(This testimony was given to the New York City Landmarks Preservation Commission on June 17<sup>th</sup> 2008 regarding the proposed addition to the Park Bernet building)

Good evening. My name is George Janes. I am appearing here on behalf of New Yorkers for Responsible Development.

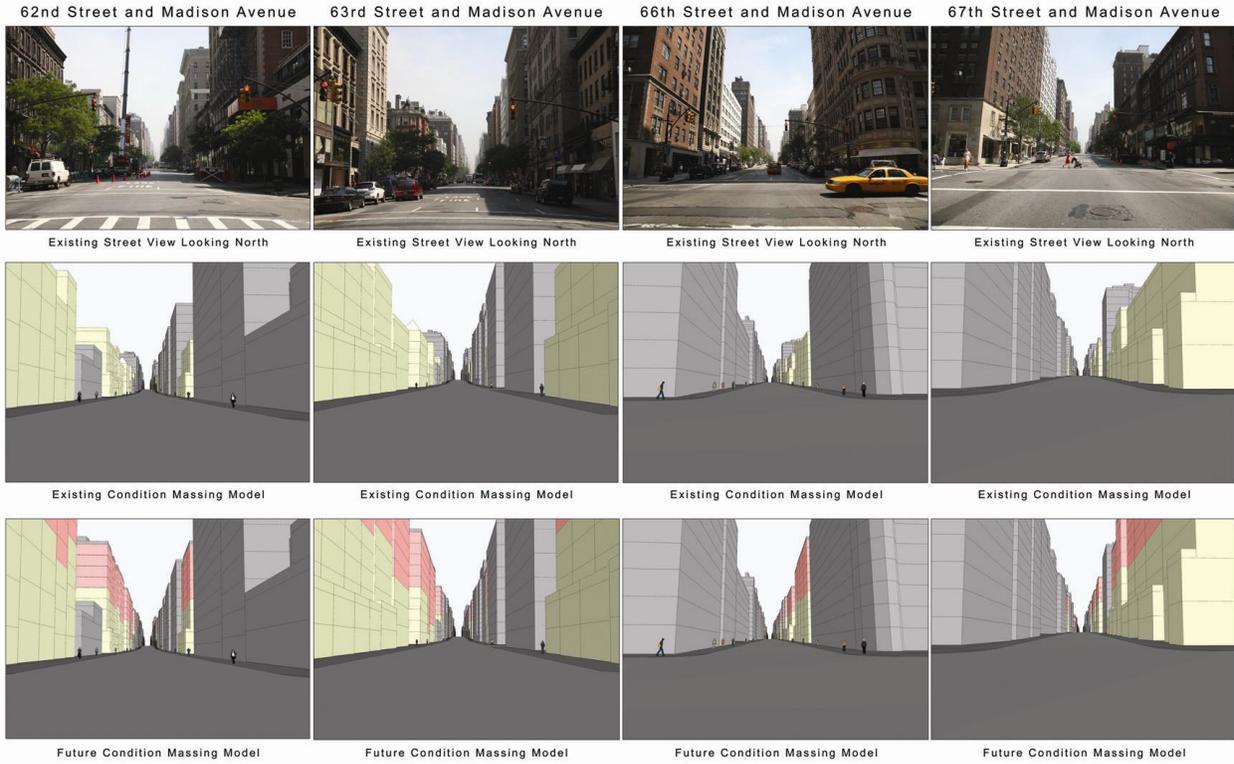
Not including houses of worship, there are currently 99 properties along Madison Avenue in the Historic District that are lower than the Park Bernet Galleries. (Noted in yellow on this map) Madison is much lower than Park and Fifth, but there is a diversity to the built form. It is not exclusively low, but alternates between high and low.

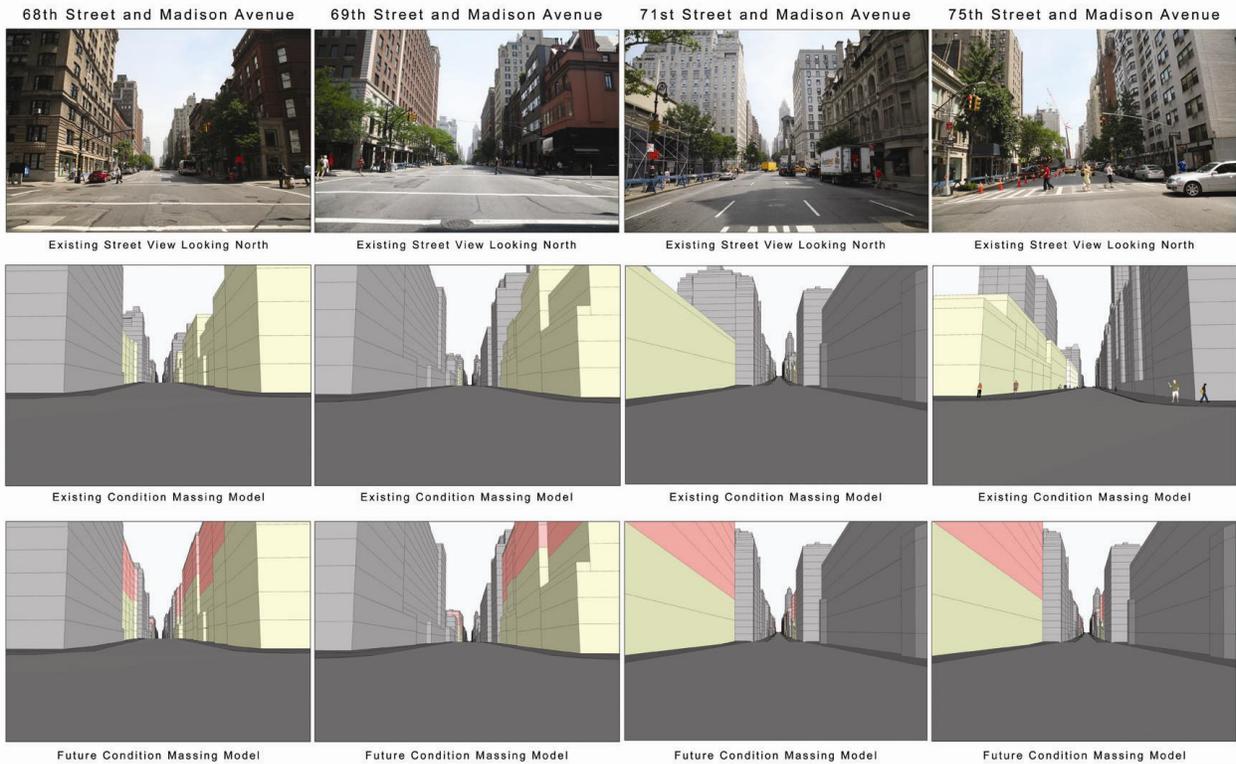
As we walk up Madison, at 63<sup>rd</sup>, 66<sup>th</sup>, 67<sup>th</sup> St, the pattern is repeated. While the current urban form alternates between high and low--giving considerable access to the sky even near tall buildings--the additions narrow the view corridor and would make a narrow street like Madison Avenue measurably darker.

The walk continues up to 68<sup>th</sup>, 69<sup>th</sup>, 71<sup>st</sup> and 75<sup>th</sup> Street. If the additions don't affect one side of the street, they affect the other.

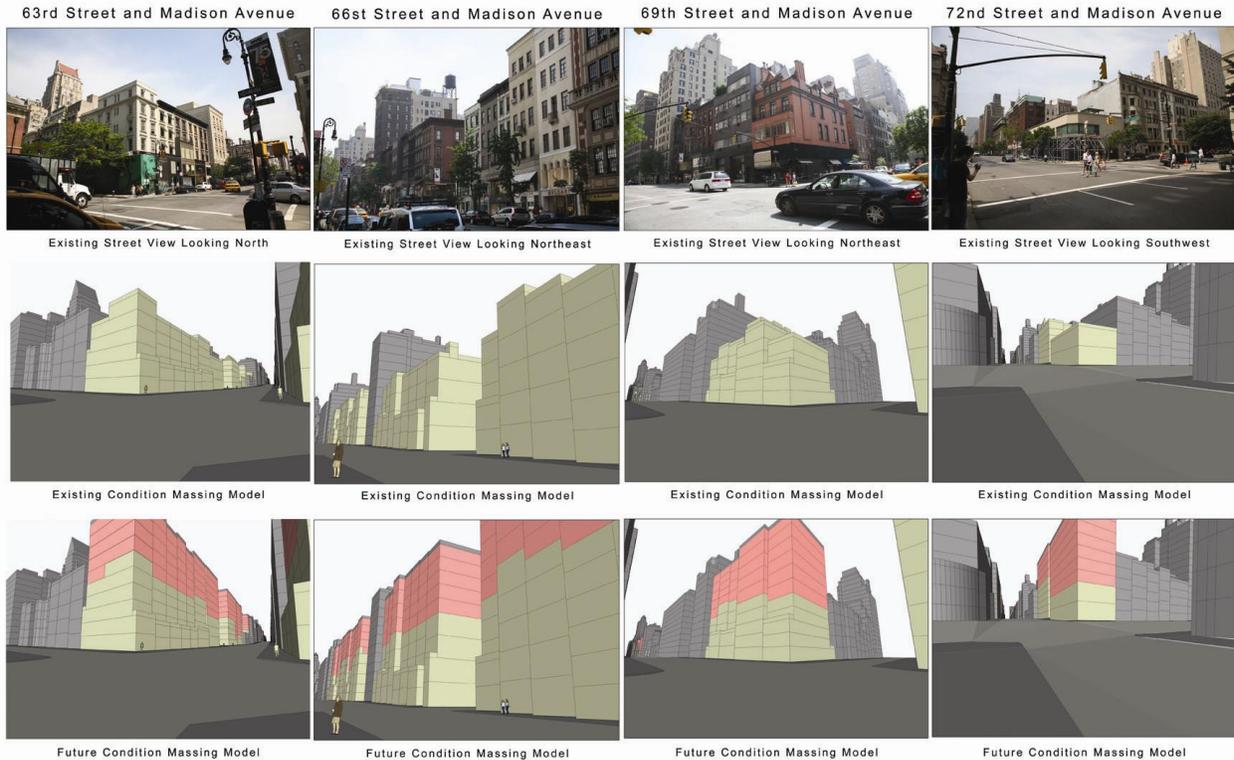
On some blocks the change in the character would be dramatic.

Instead of looking straight north, this board shows looks at street fronts along 63<sup>rd</sup>, 66<sup>th</sup>, 69<sup>th</sup>, and 72<sup>nd</sup>, all of which would show a dramatic change from their existing rowhouse character.

On the Parke Bernet site itself, the addition will fill the only low portion of the block that gives considerable access to the sky from street level and will enclose and narrow that portion of Madison Avenue.
